ADDENDUM NO. 3

Perry Township Schools:
Southport High School Addition & Renovation Phase 1 (Activity Center Addition &
Wrestling/Center Plant Renovation)
971 E. Banta Road
Indianapolis, IN 46227

ADDENDUM NO. THREE

DATE OF ADDENDUM: February 12, 2026

C-8.18

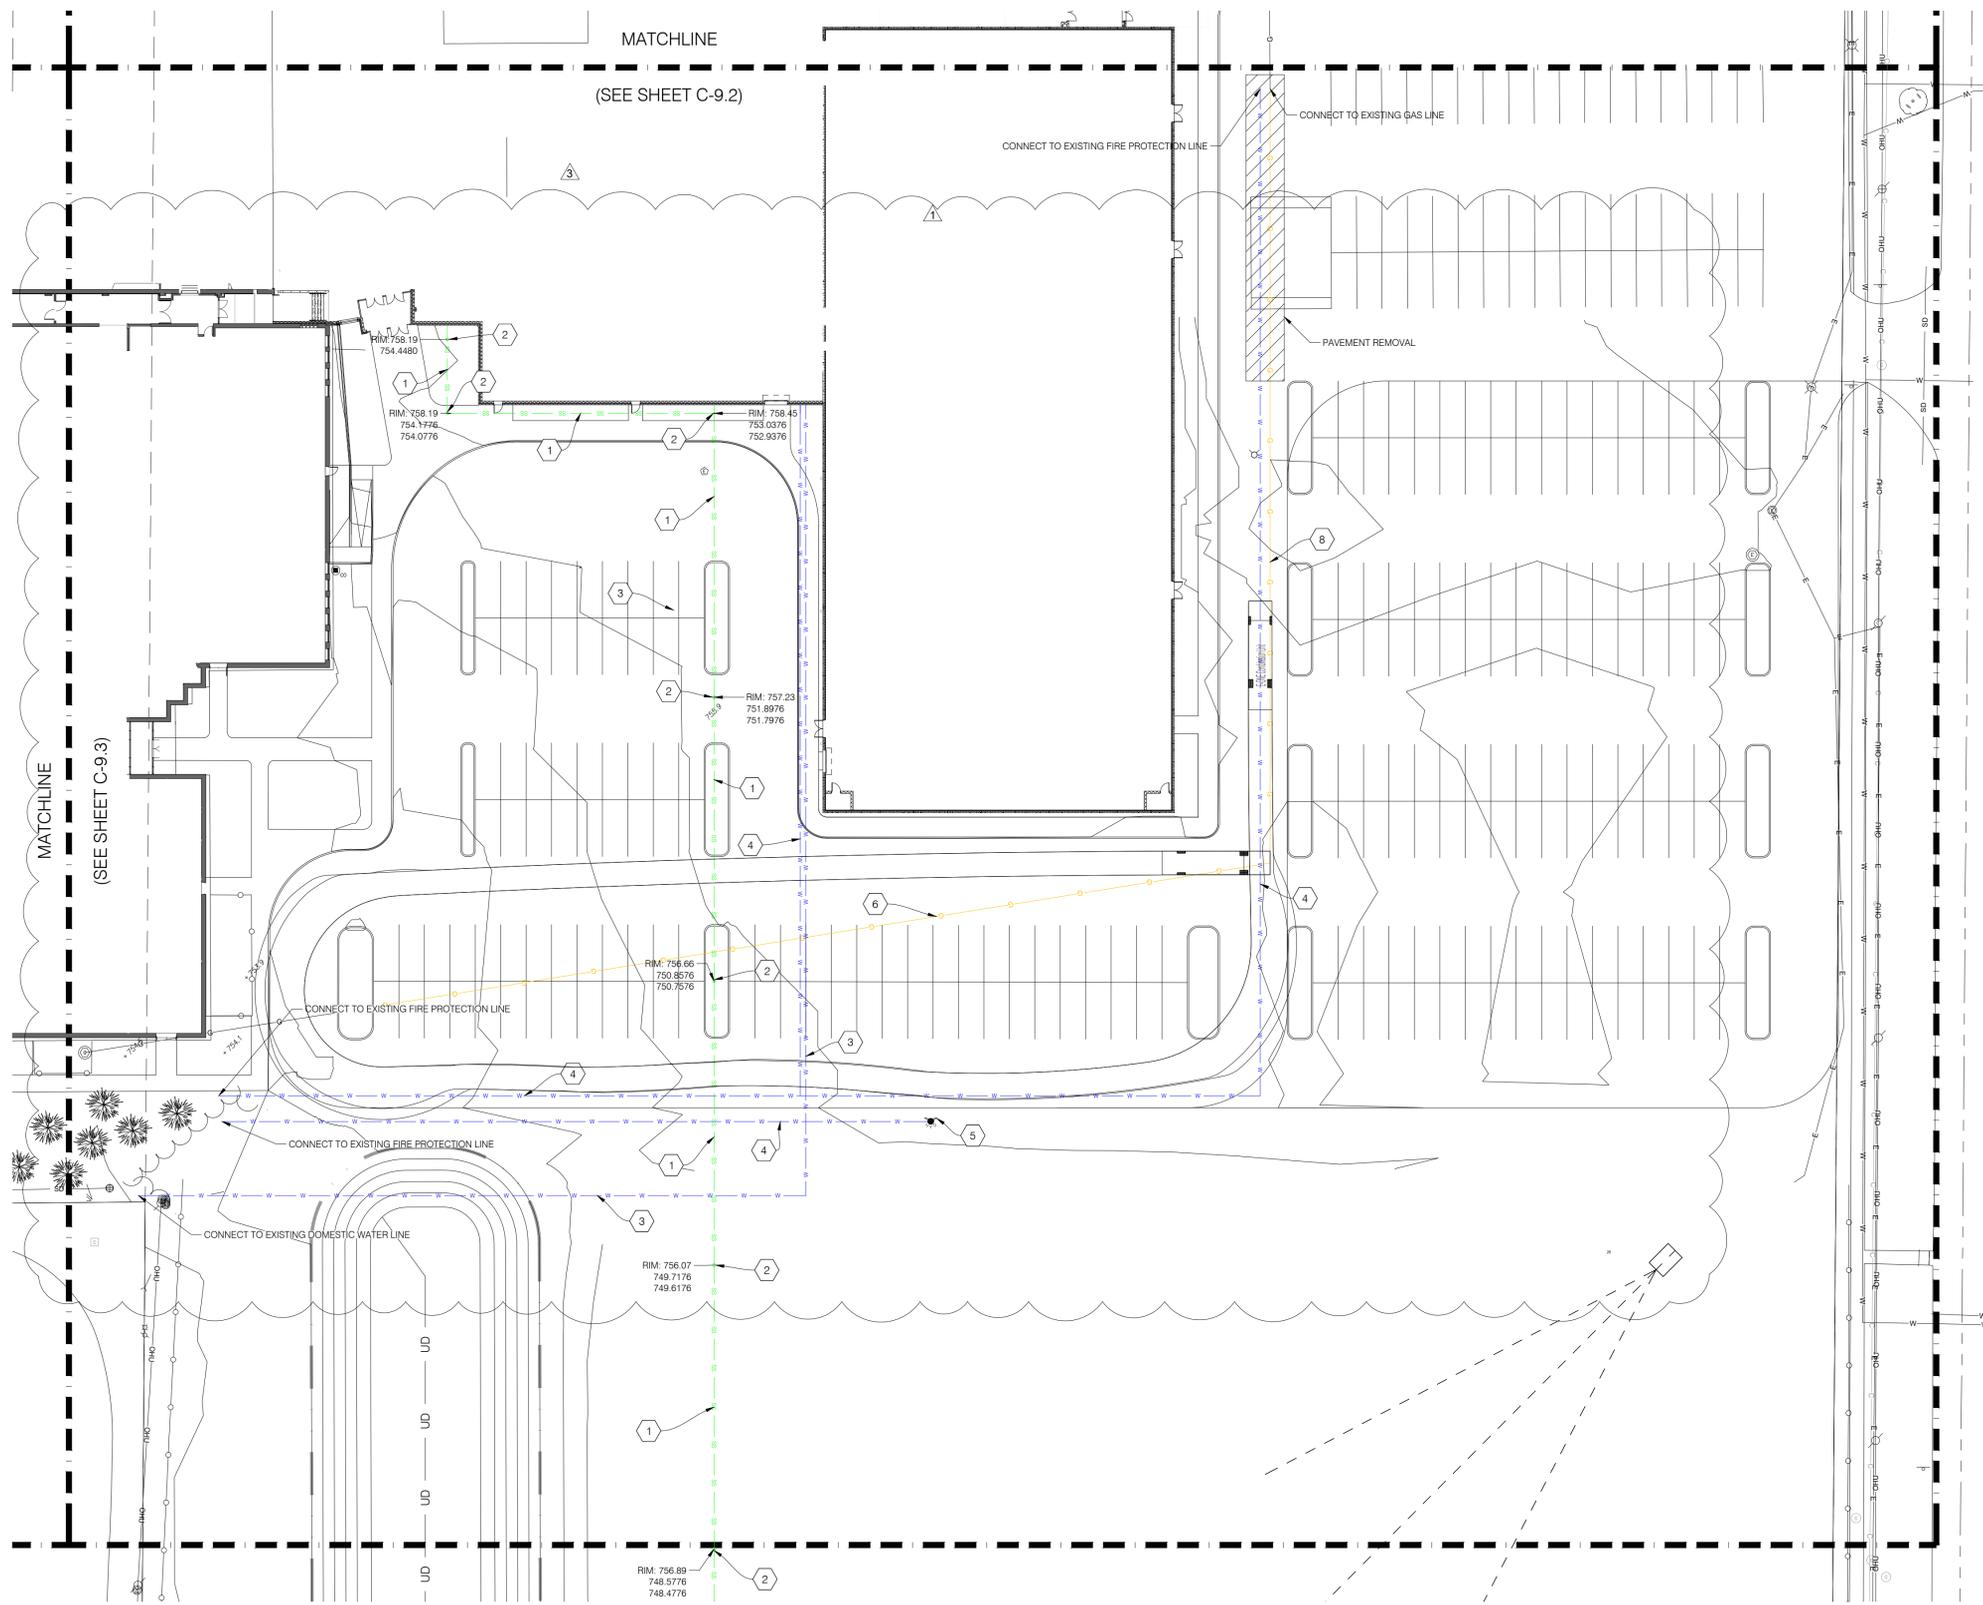
Change: New sheet to the drawing set.

LOAD MAPS

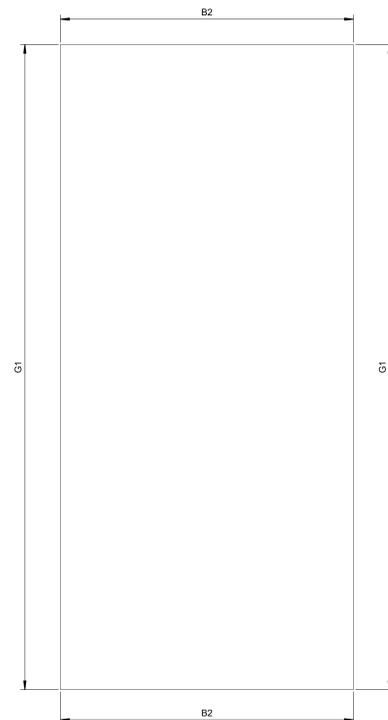
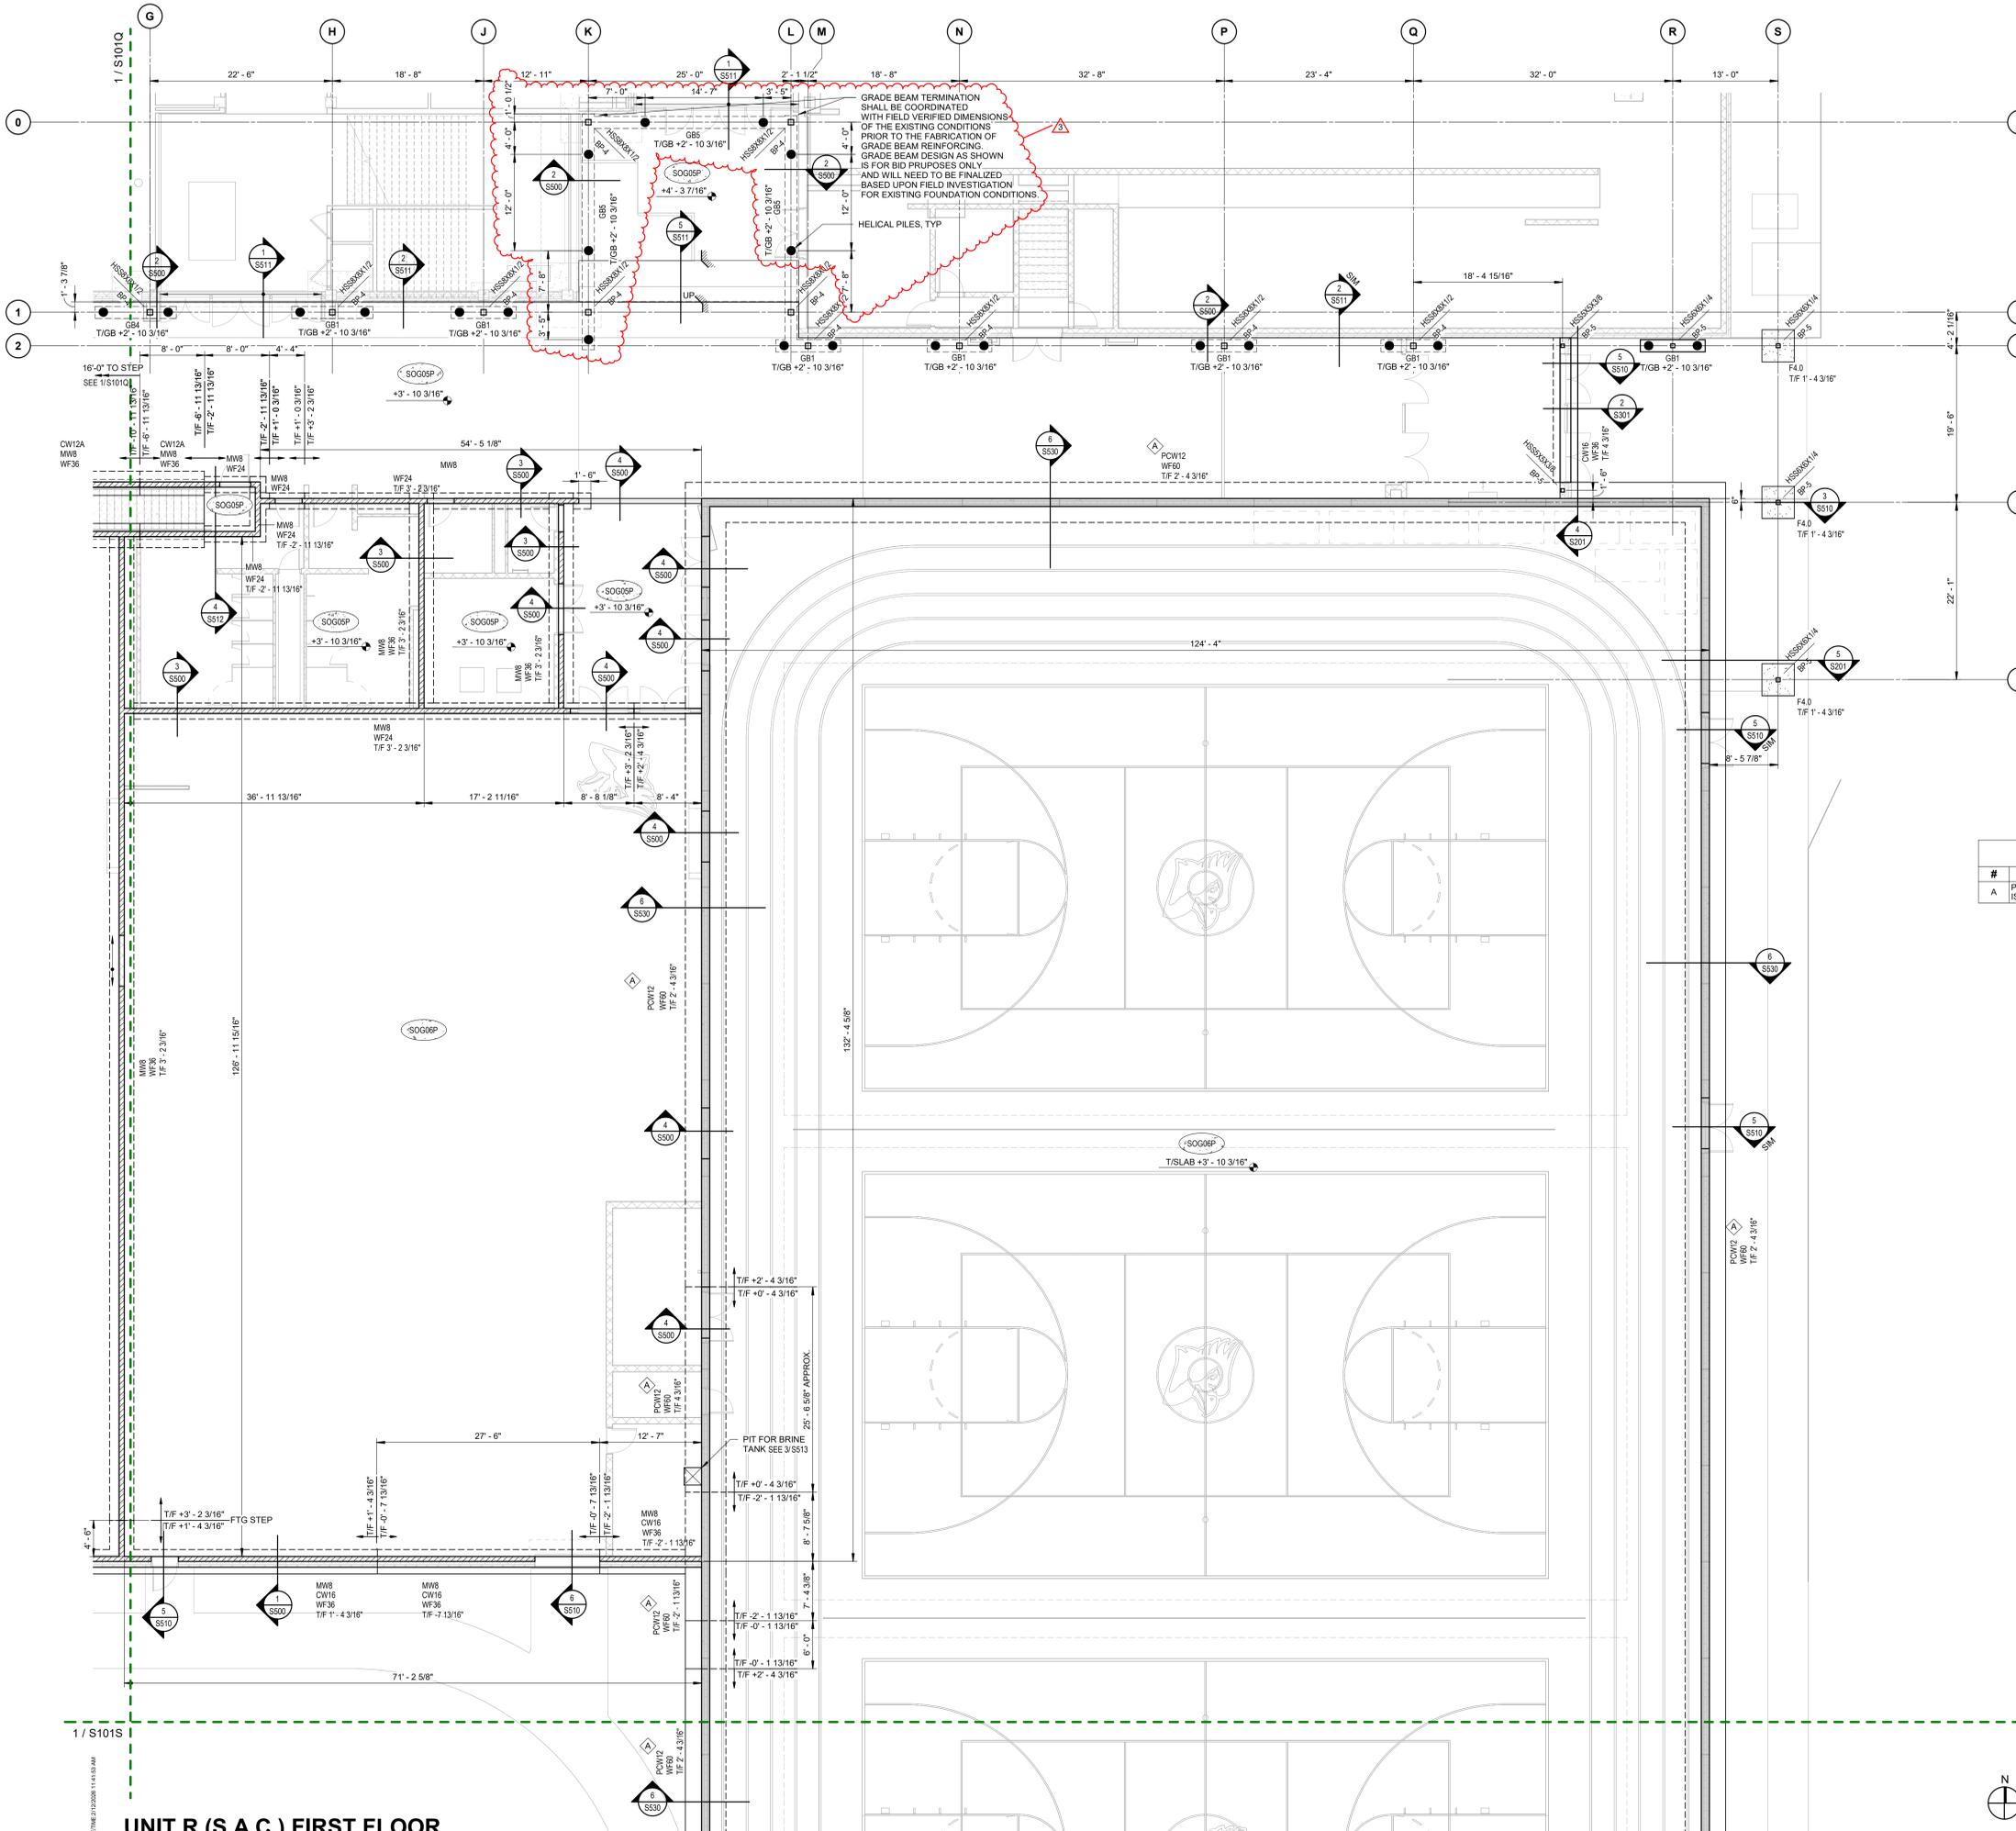
Change: Load Map: Steel Bearing 4 & Precast Point Loads.

- Added note regarding roof trusses bracing precast panel at the correct bearing level (Steel Bearing 4).
- Updated out-of-plane and in-plane loading.

UNIT R (S.A.C.) FIRST FLOOR
SCALE: 1/8" = 1'-0"

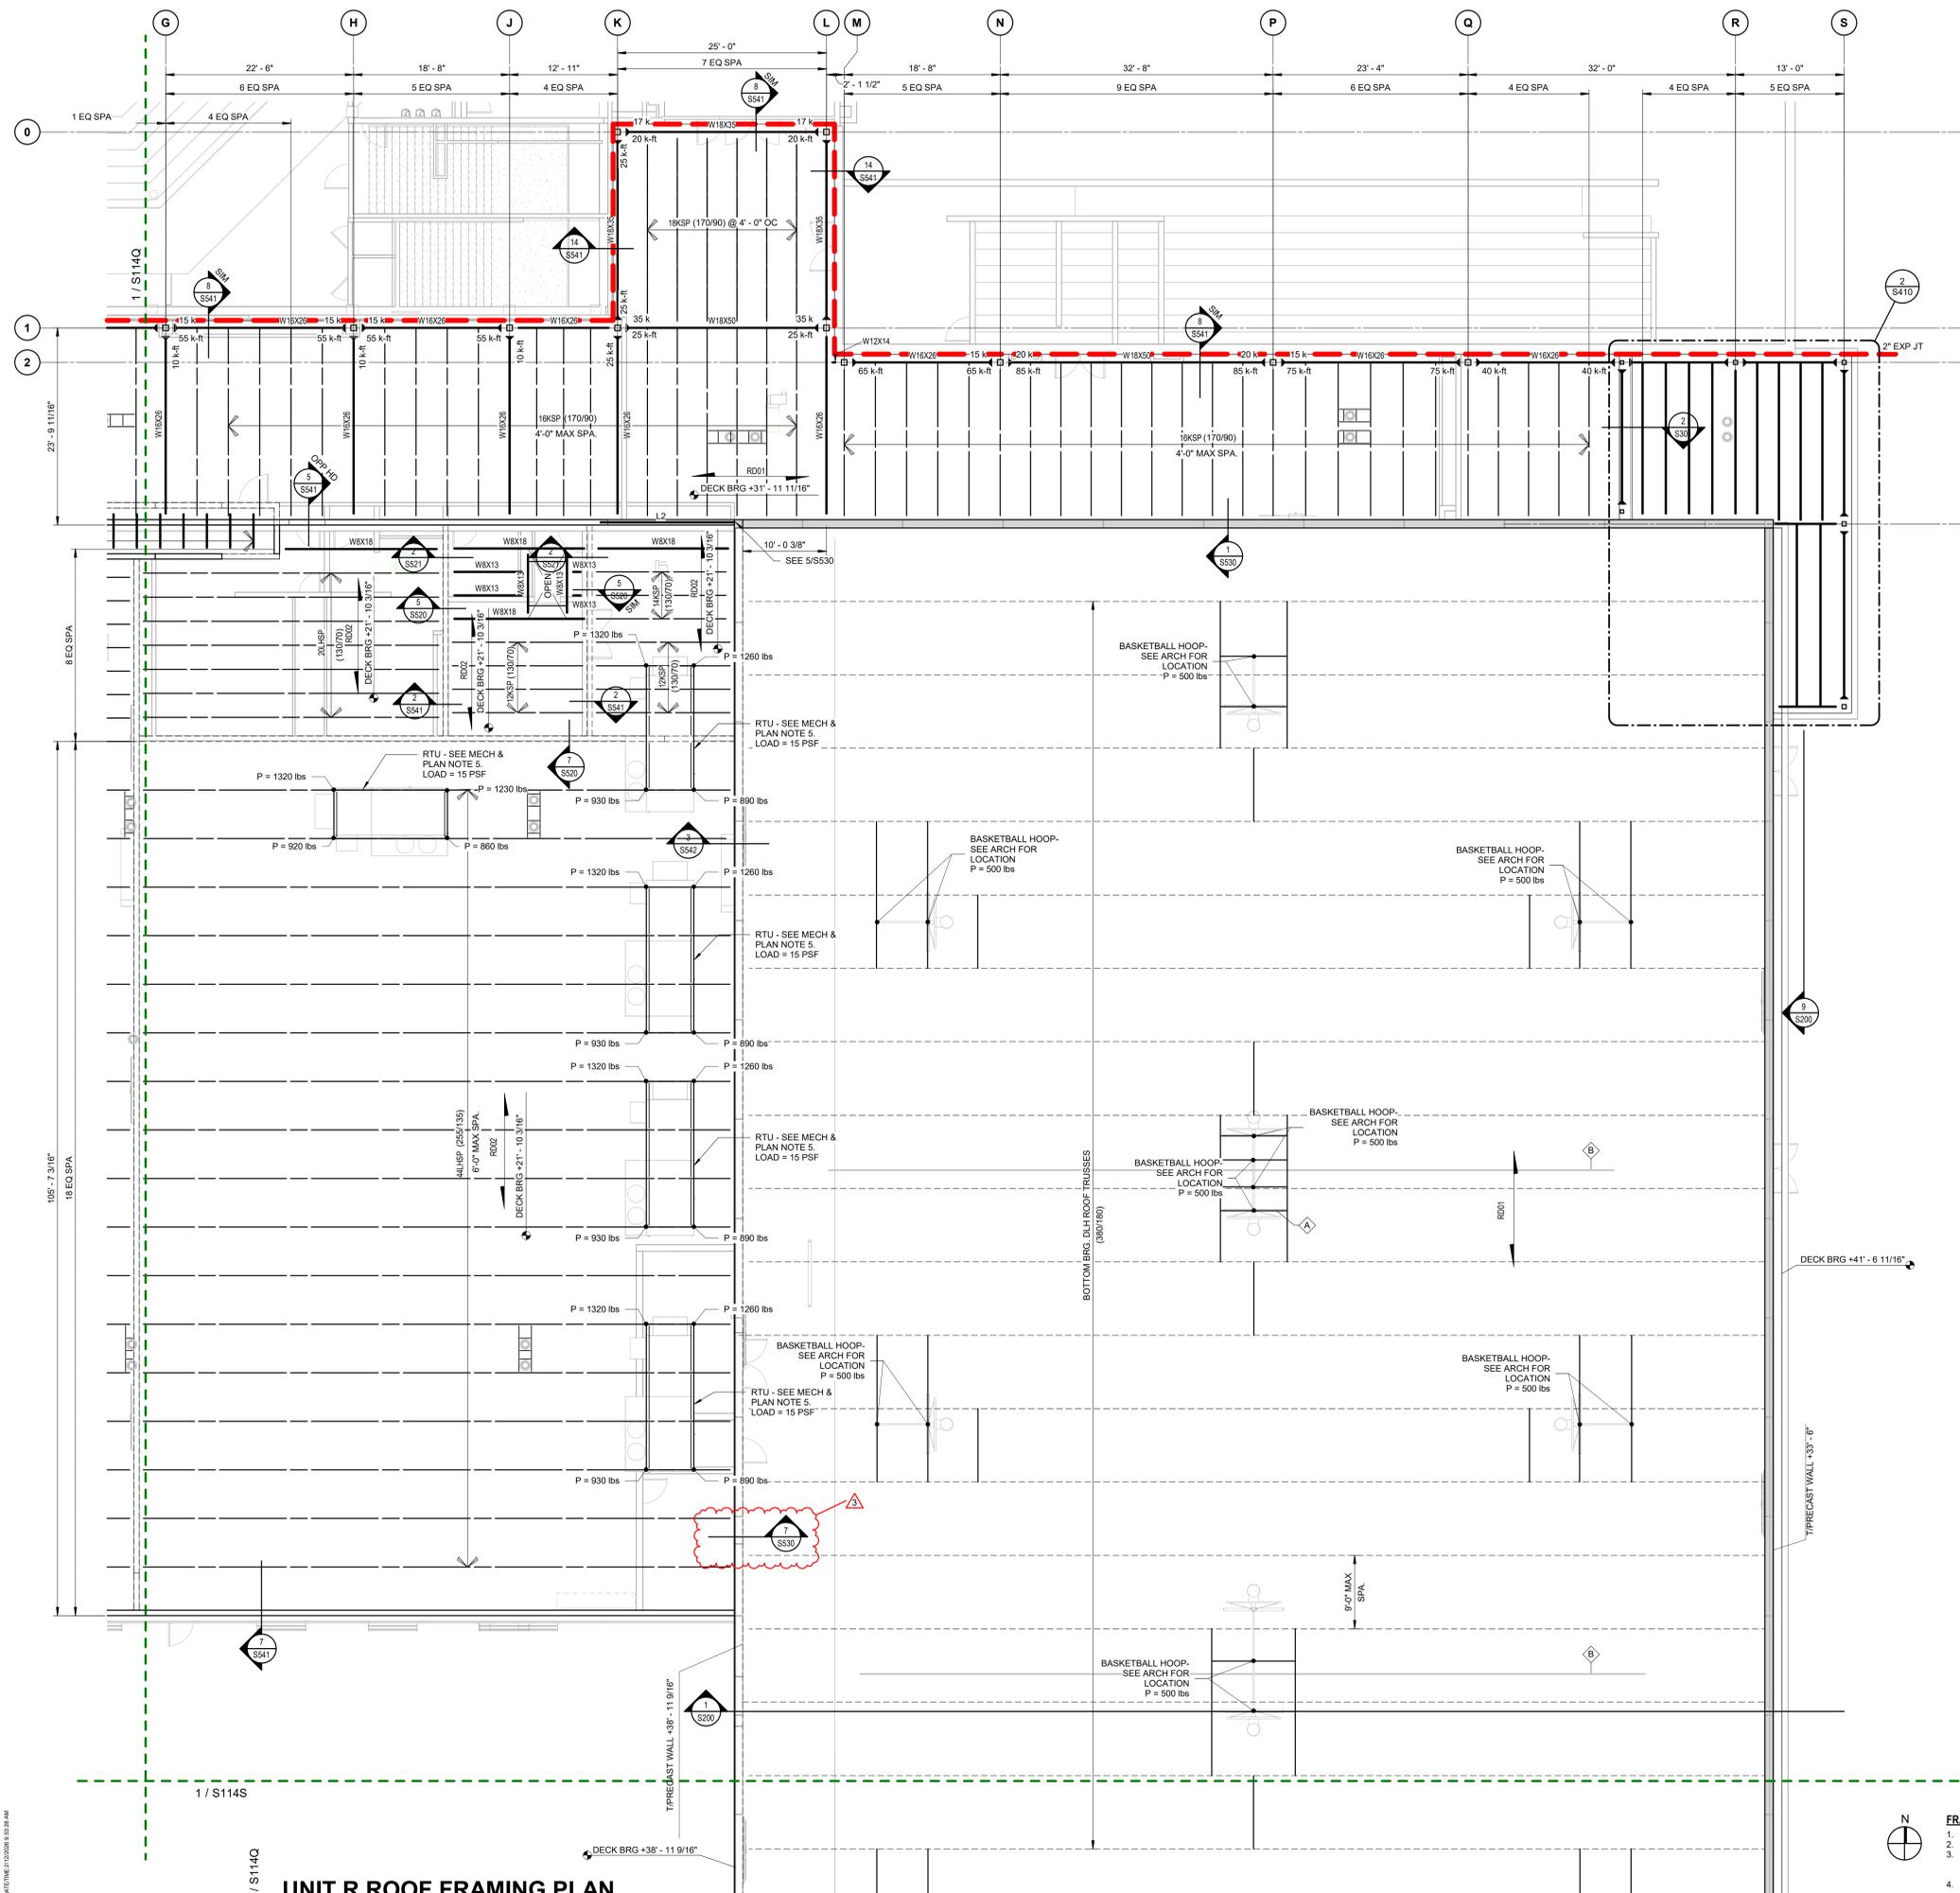
Change: Foundation Plan Annotation.

- Added GB5 tag note regarding GB5.
- Added dimensions regarding GB5.
